Re: DSUP #2024-10008/5216 Seminary Townhomes

Opposition To Plan For 7 Large Townhouses For 5216 Seminary Road

Re: Proposed Preliminary Site Plan For 5216 Seminary Road

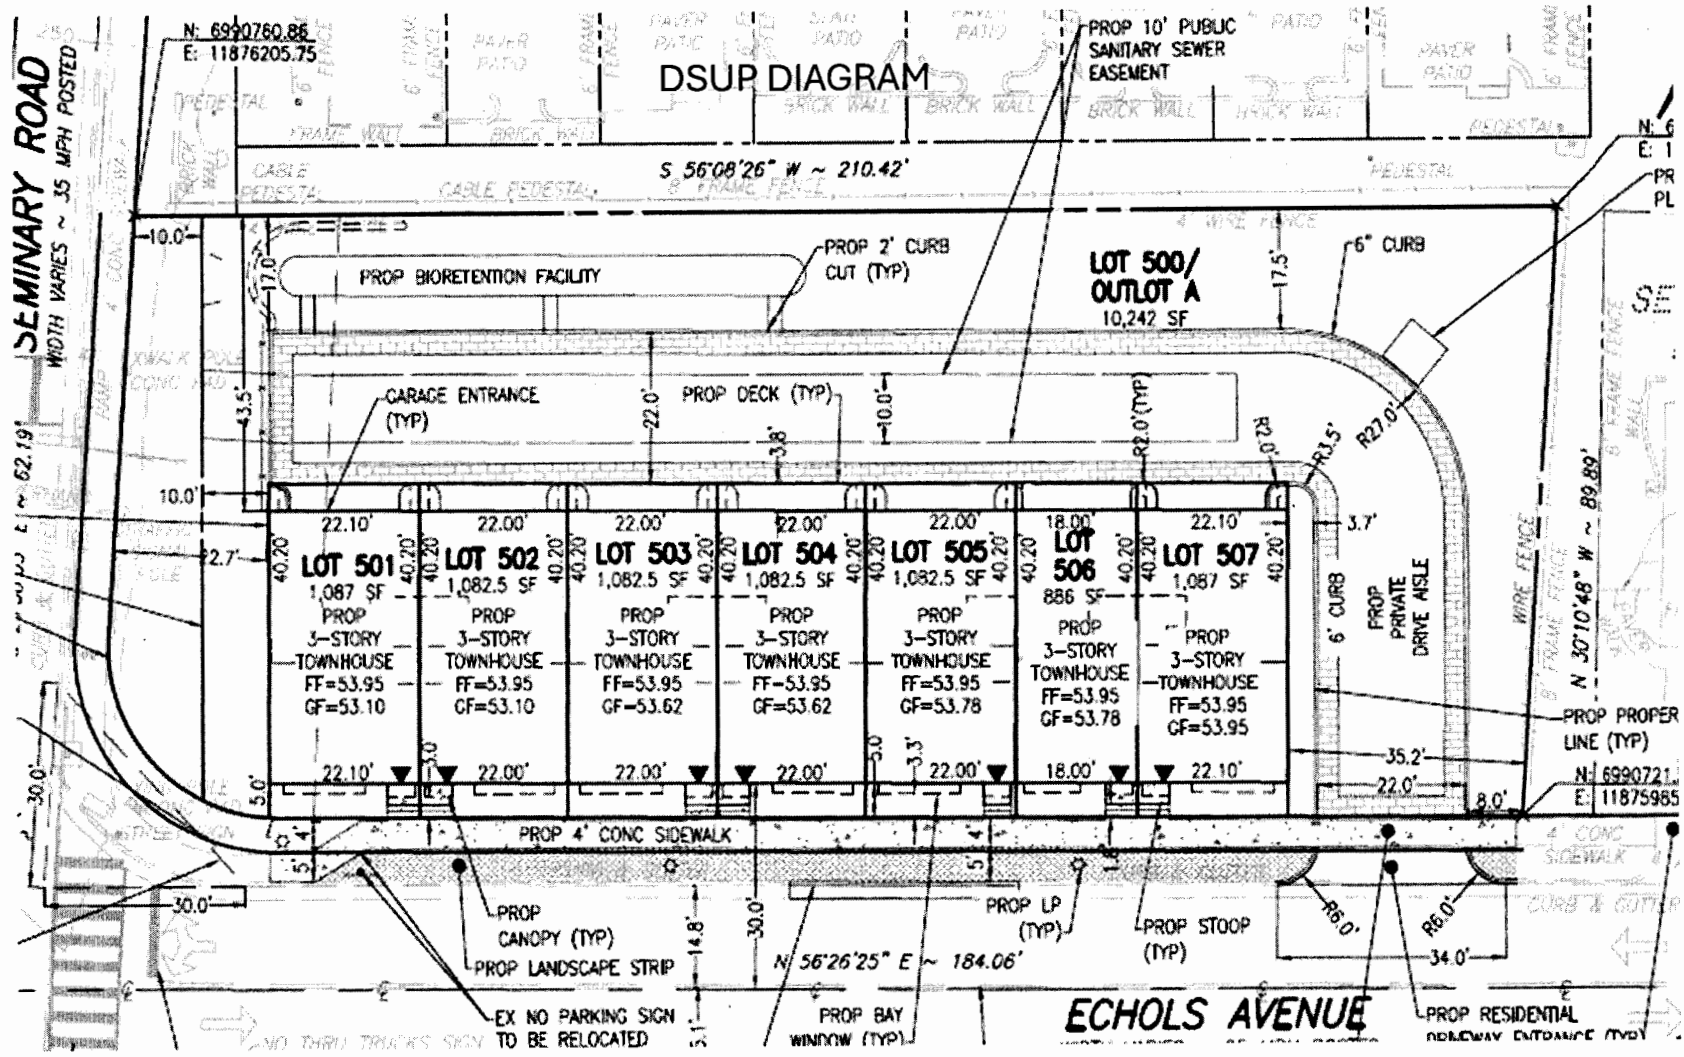
- 11-605-(B)(1) requires a general layout plan depicting the density, design and development potential of the subject property under all regulations of the applicable zone without a cluster design
- The 7 larger townhouses would fail the ordinary requirements
 - The larger townhouses fail because a 20 ft front yard requirement + 40 ft townhouse + 44 ft rear yard requirement (1:1)=104 ft
 - The depth of the lot is only 90 ft
- The baseline townhouses are a lot smaller
 - As an example, the baseline townhouses are 29 feet high instead of 44 feet for the DSUP townhouses
 - The ground dimension is 26 ft x 22.25 ft for the 5 middle townhouses instead of what appears to be 22 ft x 40.2 feet for 4 of the middle in the DSUP Townhouses

The Proposal Fails the Equivalent Land Determination

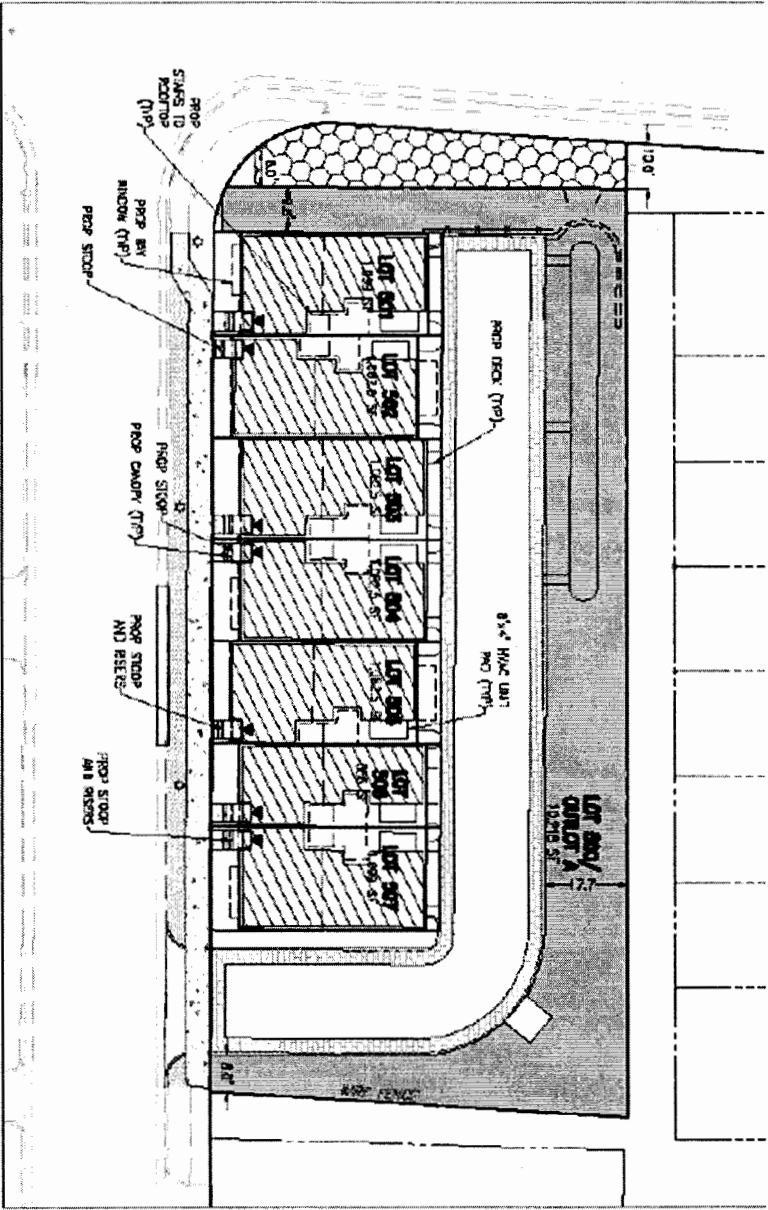
- The staff incorrectly calculates the reduction in lot size to be from zone RB minimum lot size requirements instead of from the baseline diagram which reflects the full range of issues that affect lot sizes

- The latter include issues like corner lots, required set-backs and yard requirements
 - Staff calculates a deficit of (-6,446 SF) while we calculate (-11,230 SF) from the baseline diagram to determine the necessary “equivalent amount of suitable land.....”

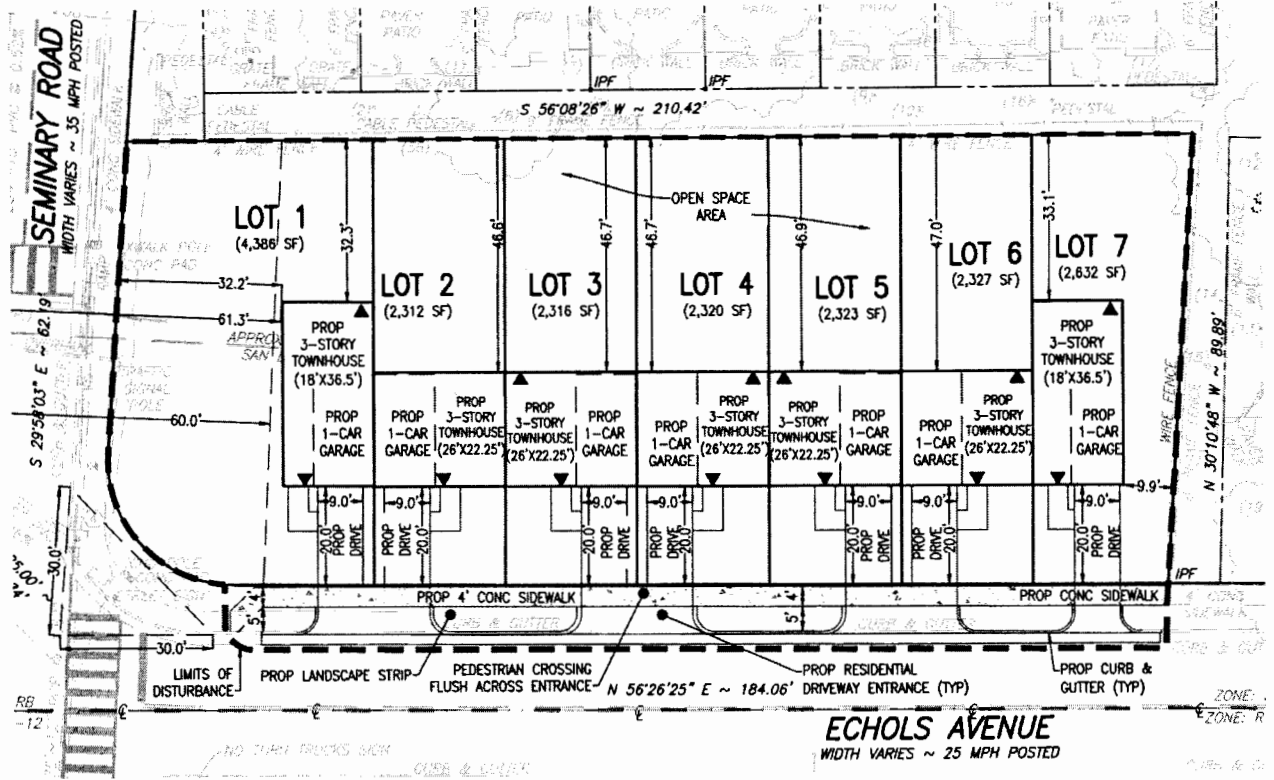
It is apparent that the floor area under the cluster design is much larger both on a lot-by-lot basis and in total.

We note we are skeptical that the applicant's diagram that the non-cluster design with the 29-foot high buildings are credibly 3-stories. If not the square feet calculations would be even smaller for the baseline proposal.
